適航指令發布單

主旨摘要 Subject	Fuel - Cylinder Quick Shut-off Valve Mounting Flange - Inspection / Replacement		
民航局 CAA <input type="checkbox"/> 本國產品 Native product <input type="checkbox"/> 其他個案 Other	設計國民航主管機構 Original Authority <input type="checkbox"/> FAA <input type="checkbox"/> Germany LBA <input type="checkbox"/> EASA <input type="checkbox"/> CAA-NL <input type="checkbox"/> Brazil <input checked="" type="checkbox"/> UK CAA <input type="checkbox"/> Transport Canada Civil Aviation <input type="checkbox"/> Japan CAB <input type="checkbox"/> DGAC <input type="checkbox"/> CAA of Israel <input type="checkbox"/> Other _____		
	設計國 AD 編號 Original AD number	G-2021-0014R1-E

Number: G-2021-0014R1-E

Hot Air Balloons – Fuel – Cylinder Quick Shut-off Valve Mounting Flange – Inspection / Replacement

Figure 1: *CB437 Flanged Adaptors for Quick Shut-Off (QSO) valves*

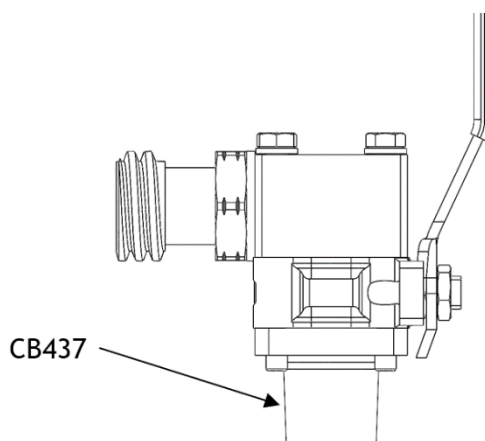
Certain Cameron Hot Air Balloon fuel cylinders are supplied with liquid offtakes that consist of a quarter turn ball valve mounted on a flanged adaptor (P/N CB437, see figure 1). Two recent batches of these adaptors have been manufactured with non-conforming (undersize) threads.

In certain cases, when the minimum sized adaptors are combined with cylinder bosses at maximum tolerance dimension and assembled to fuel cylinders, the thread can impinge ("bottom out") on the cylinder boss. Although the required tightening torque value can be achieved at installation, the torque required to unscrew the flange could be below the minimum value. In extreme cases the adaptor may be unscrewed by hand.

4. From the 04 October 2021 (the effective date of AD G -2021-0010-E), do not install an affected part on any cylinder.
5. Within 4 months after 04 October 2021 (the effective date of AD G-2021-0010-E), modify each cylinder by replacing the P/N CB437 issue F QSO flanged Adaptor, with a P/N CB437 issue H (or later issue) QSO flanged adaptor in accordance with the instructions of the SB, or by replacing the QSO valve assembly with a handwheel valve part No CB0824-0001 (this part has a Rego-type hose connection).
